**RE: Tentative Parcel Map No. 061676
720 South San Rafael Avenue
725 South Hillside Terrace
Hillside Development Permit 4595**

RE Addendum Report to Report of June 21, 2004
720 South San Rafael Avenue

The following is an addendum to the report of June 21, 2004, as requested for you by Dennis Smith, Architect. The reason for the addendum is to respond to the "Review of Soils Report dated June 21, 2004 by Robert D. Cousineau____", prepared by Sassan Geosciences, Inc., dated August 23, 2005

PROJECT NO.	04-138
PLATE	D

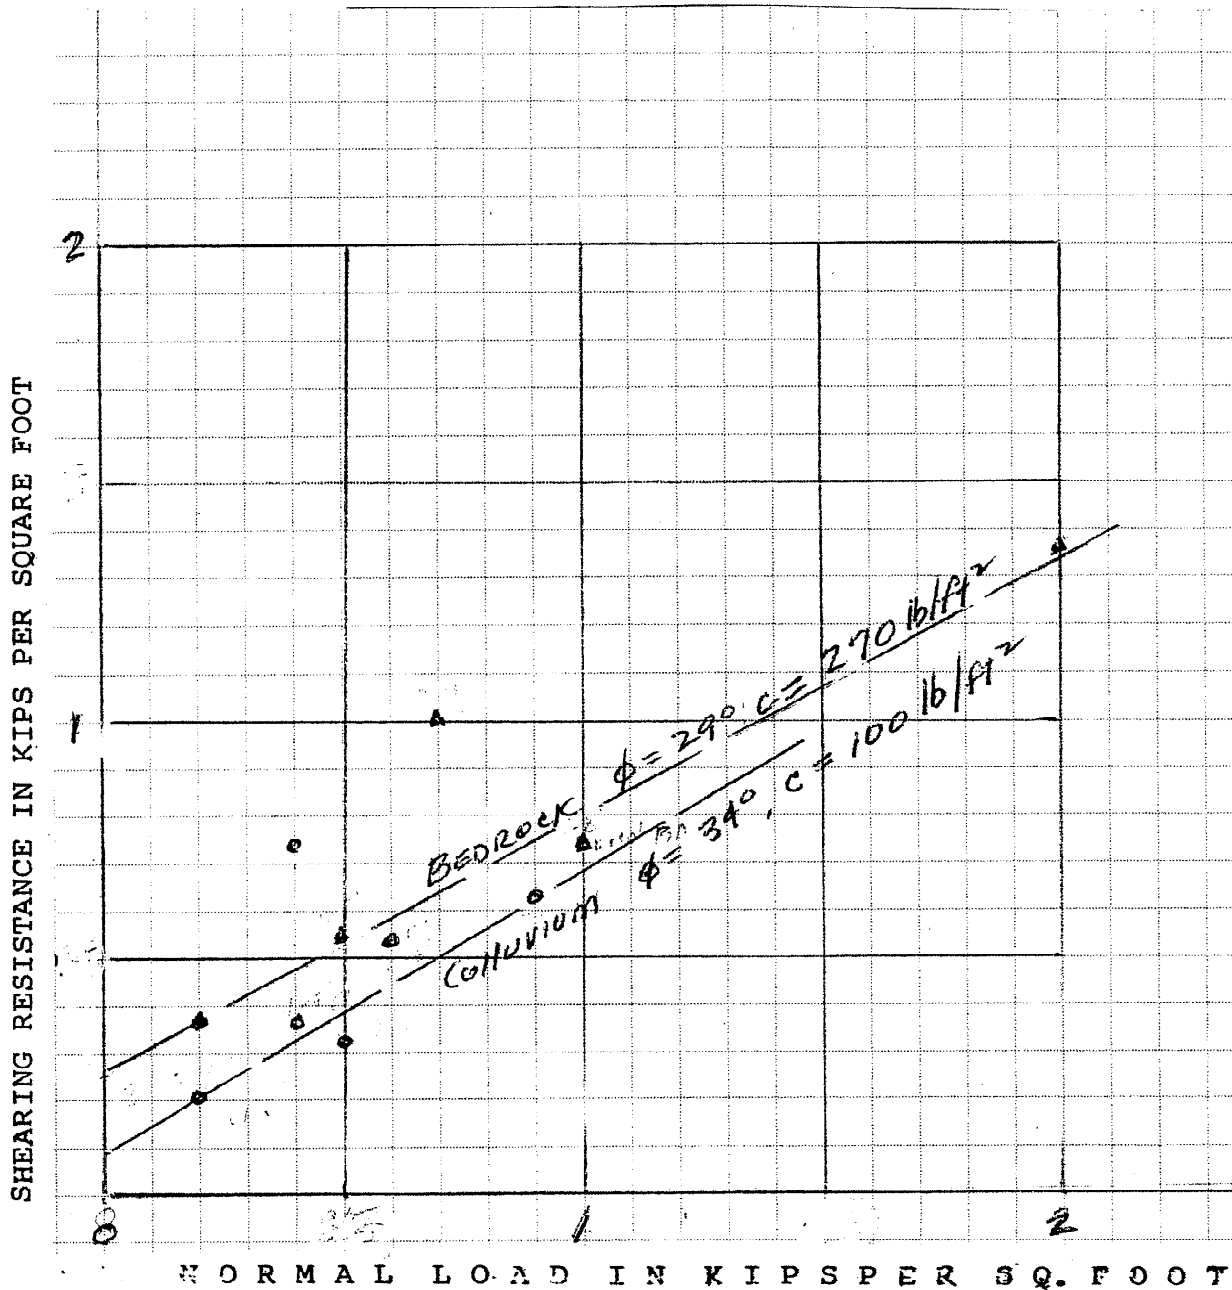
The direct shear tests do not classify the colluvium as silty sand but rather, silty clay. Their statement to the contrary is not correct.
